## **REEVALUATION OF FINDING OF NO SIGNIFICANT IMPACT (FONSI)**

### **SEVIERVILLE WATER SYSTEMS (SWS) RAW WATER INTAKE AND WATER TREATMENT PLANT – FRENCH BROAD RIVER MILE 27.5L, SEVIER COUNTY, TENNESSEE**

RE File No. 200400150  
McCroskey Island WTP  
Sevierville, TN  
WRC Job# 333

TEMPORARY BRIDGE

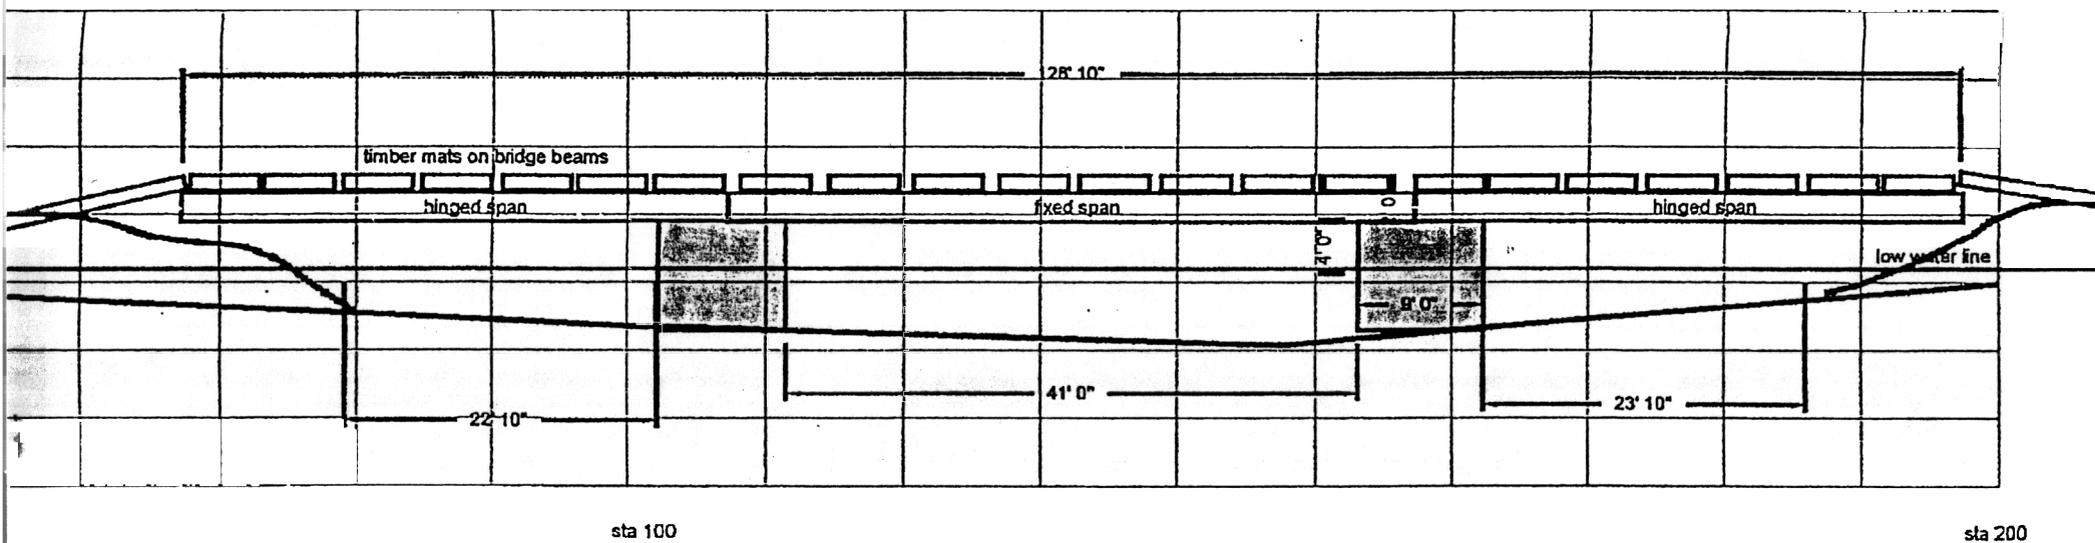
4. Pad Length: Could you avoid placing the pad segment between the shoreline and existing gravel bar (i.e., roughly Sta. 0+00 and 2+50) to alleviate concerns for possible obstruction of the Little Pigeon River flows?

1. Attached find revised FMSM Engineers' drawing to reflect bridge over the Little Pigeon River as requested. Also find attached Jordan, Jones & Goulding drawings CG1.2 and CG1.4 which show fill area at New Treatment Plant site. Left over stone/rip rap will be incorporated within the shown fill areas.
2. Sequence of Construction: Upon approval, bridge will be installed taking two (2) weeks. Rip rap will be hauled across bridge and into river taking another two (2) to four (4) weeks. As we approach Station 8+00, it will be determined if we will need to fill to Station 11+00. 3700 CY of stone is required.

The temporary bridge, beginning about 60 feet from the water treatment plant shoreline, would extend into the river about 128 feet to connect with the rock pad at the base of a gravel bar at about Station 2+00 (or 200 feet from shore). It would be constructed of timber mats on bridge beams and supported at two locations by 9-foot wide barges proposed to be sunk in the river. Approximately 22 feet of both ends of the bridge would be hinged to allow a sloping angle and appropriate movement as a vehicle and other equipment crosses, while a 41-foot section in the middle of the bridge

would have a fixed span (see bridge plans for location and more details attached to this FONSI). There would be 4 feet of clearance between the bottom of the bridge and projected low river flow elevation (862.4-foot msl). During high flows, boats would be able to pass along the right descending shore. The bridge and pad would be marked and lighted so they would not to become a hazard to recreational boating.
